Product Change Notification

Change Notification #: 118653-00
Change Title: Select Intel® Ethernet Network Adapter OCP 3.0 X710-T4L, Intel® Ethernet Network Adapter OCP 3.0 X710-T2L, Intel® Ethernet Network Adapter OCP 3.0 X710-DA4 and Intel® Ethernet Network Adapter OCP 3.0 X710-DA2 SKUs, PCN 118653-00, Product Design, Label, Product Material, FVL8.5 NVM & UKCA Logo Update and Faceplate Update
Date of Publication: November 05, 2021

Packaging Label Update

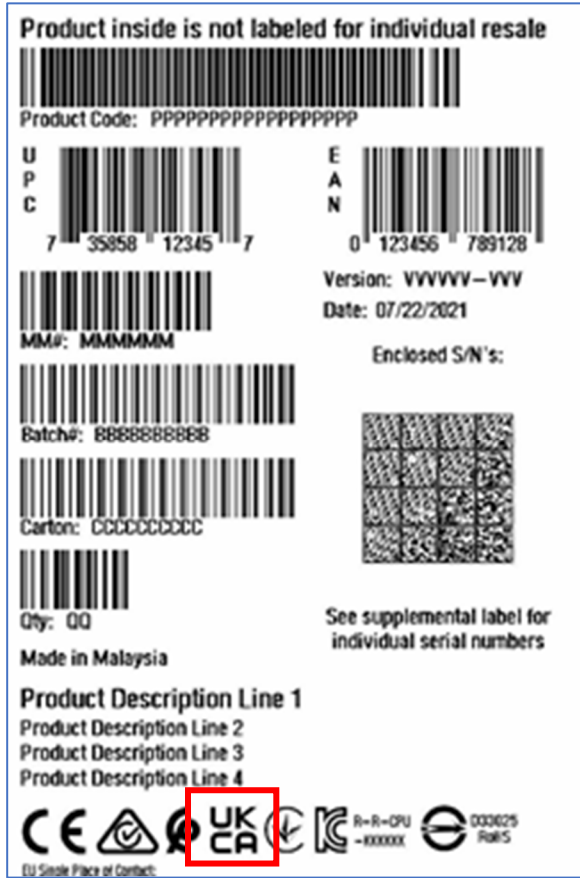
2. OCP 3.0 regulatory update with UKCA marking. Packaging label includes UKCA marking.
3. The Intel® Ethernet Network Adapter OCP3.0 X710-DA4 will be updated to use an enhanced OCP3.0 faceplate. The updated faceplate has been enhanced to ensure all mechanical dimensions have tighter tolerances to meet OCP3.0 mechanical Critical to Function requirements.

- c. Packaging label includes UKCA marking.
